SEPTIC REVIEW CERTIFICATION

Permit No. 24-052315-SE

Description of proposed work for this Septic Planning Review
Temporary permit for onsite construction administration office trailers at the Filtration Facility site

Bull Run Filtration Pipelines
RAW WATER PIPELINE EROSION AND SED CONTROL
UTILITY WORK 1
GRID 2

PROPOSED CONDITIONS PLAN
GRID 1,GRID 2, GRID 3

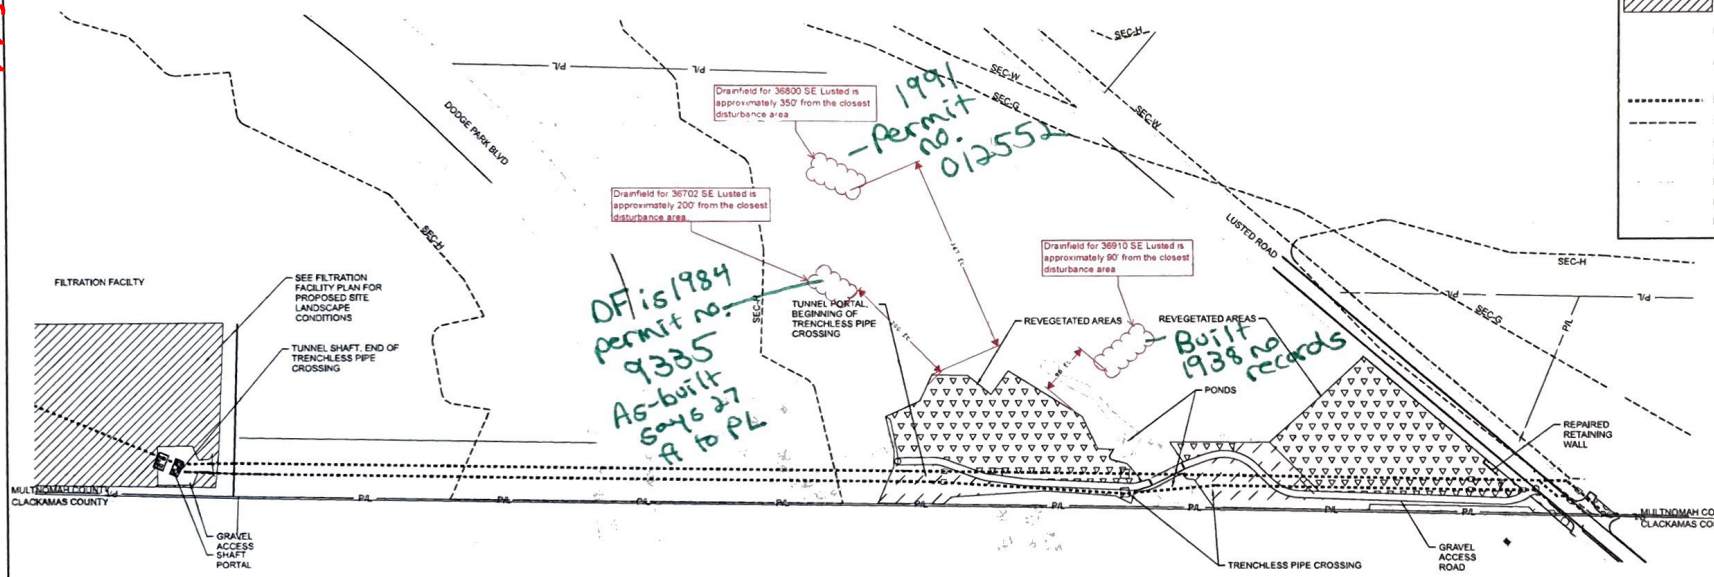
Conditions/Comments: Proposed portable septic holding tank for temporary trailer office with restrooms meets requirements of OAR 340-071-0340(5) provided tanks are marked with name & phone number of licensed sewage disposal service responsible for maintaining the tanks & have a secure,watertight connection to the building sewer pipe. Signed pumping contract with DEQ-licensed pumper received. Placement of temporary trailer office does not impact neighboring septic systems as shown on included site plan. No site visit.

Septic locations based on inspection records and site walk with property owners

300 GAL

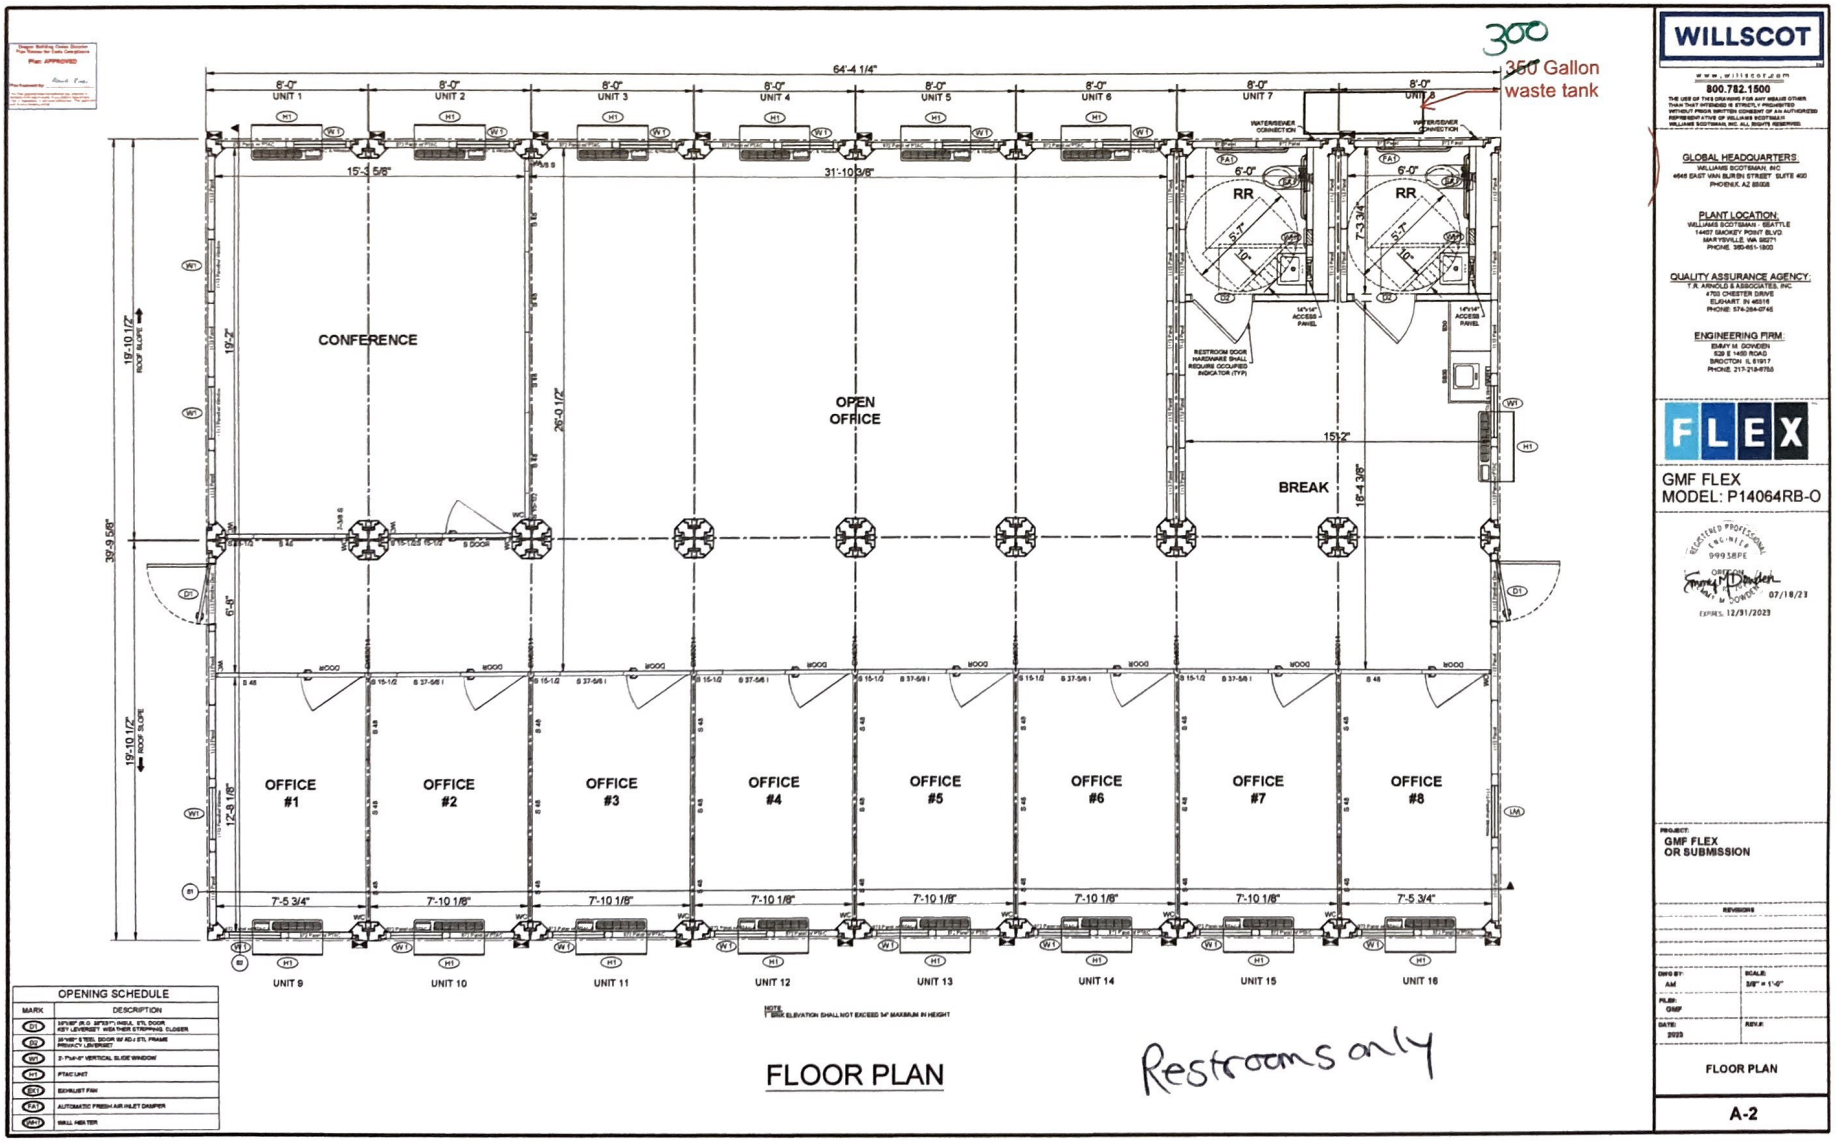
✓(B) Tank capacity may not exceed 1,000 gallons unless otherwise authorized by the agent. 300 gal

✓(D) The tank must be designed and constructed to provide a secure, watertight connection of the building sewer pipe. fernco style couplings provided
